Work Order ID 140853

Item Name: Lower Cutter Assy

ENGINEERING CHANGE NOTICE NO.		02195		SHEET 1 OF 4	
DWG NO.	646.3000	REV: N/C	PREPARED BY	S. HUFF	DATE: 01/05/09
DWG TITLE:		LOWER CUTTER ASSY			
APPROVED BY:	ENGR <i>[Signature]</i>	MFG	<i>[Signature]</i>	QC	<i>[Signature]</i>
TRANSACTION CODES (TC): A-ADD C-CREATE R-REVISE D-DELETE		REASON: REMOVED RIVETS IN FAVOR OF ADDITIONAL SCREWS			
		EFF:		NEXT ORDER

SHEET 1, ZONE D5, IS:

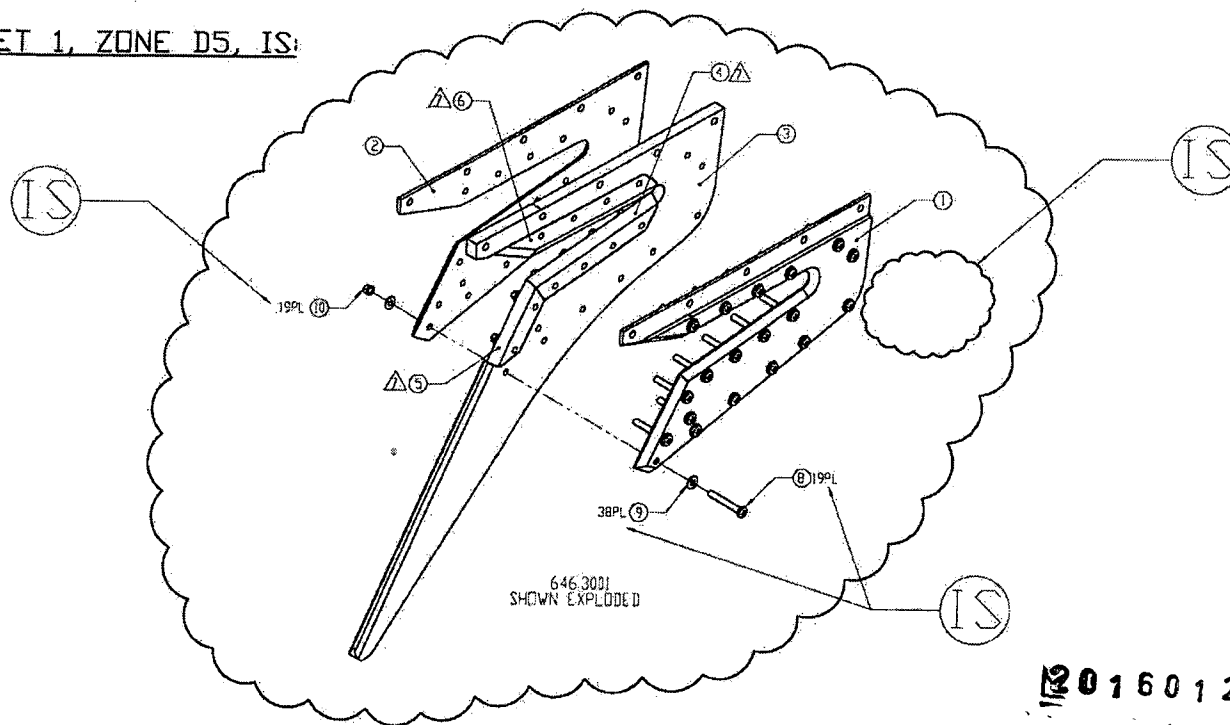
10	R	601.1541		19	LOCKNUT	MS21042L08
9	R	601.2764		38	WASHER	NAS1149FN832P
8	R	601.2765		19	SCREW	MS27039-0819
7	D	601.2766		2	RIVET	MS20470AD5-18
				3001		
F/N	TC	PART NUMBER	QTY	DESCRIPTION	MATERIAL/SPECIFICATION	
DOCUMENTS EFFECTED:					CHANGE CATEGORY	DER REVIEW REQUIRED
					☐ MAJOR ☒ MINOR	☐ YES ☒ NO
